# UNITED STATES PATENT AND TRADEMARK OFFICE

APPLICATION NO.	FILING DATE	FIRST NAMED INVENTOR	ATTORNEY DOCKET NO.	CONFIRMATION NO.
09/915,385	07/27/2001	Mikihiro Yokozeki	211895US8	9746

**Office Action Summary**

## **DETAILED ACTION**

**FIG. 4**  
**PRIOR ART**

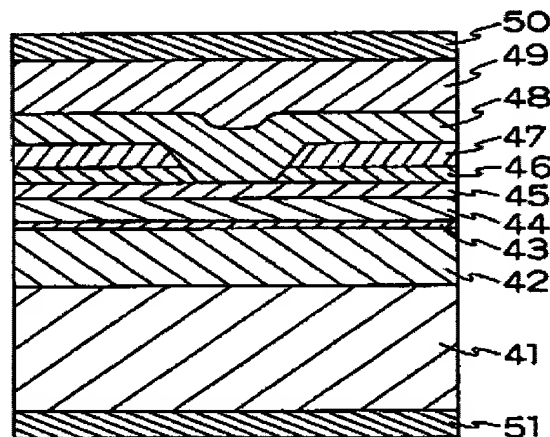
Claims 1,3,4 are rejected under 35 U.S.C. 102(b) as being anticipated by Mushiage et al (PN 5,933,443).

Figure 4 illustrates of a known prior art semiconductor laser having an etch stop layer (45) composed of InGaP, a first semiconductor layer (46) composed of AlInP and a second semiconductor layer (47) composed of GaAs, where semiconductor layers are etched until the etch stop layer. Semiconductor layer (46) contains aluminum, semiconductor layer (47) does not contain aluminum or phosphorus and the etch stop layer contains phosphorus, as described in column 1 lines 43-50.

**FIG.2**

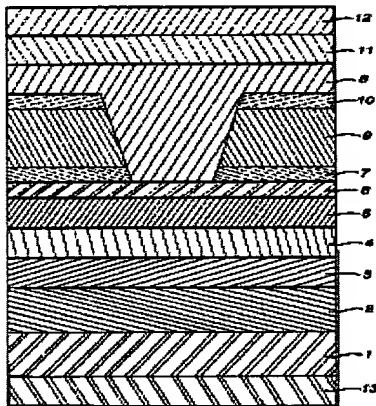
Claims 1-3 are rejected under 35 U.S.C. 102(e) as being anticipated by Horie et al (PN 6,172,998).

Figure 2 illustrates a semiconductor laser having a first etch stop layer (6), a second etch stop layer (7), a first semiconductor layer (9) and second semiconductor layer (10), where the layers are etched until the etch stop layer (6), as described in column 5 and example 1 in column 7.
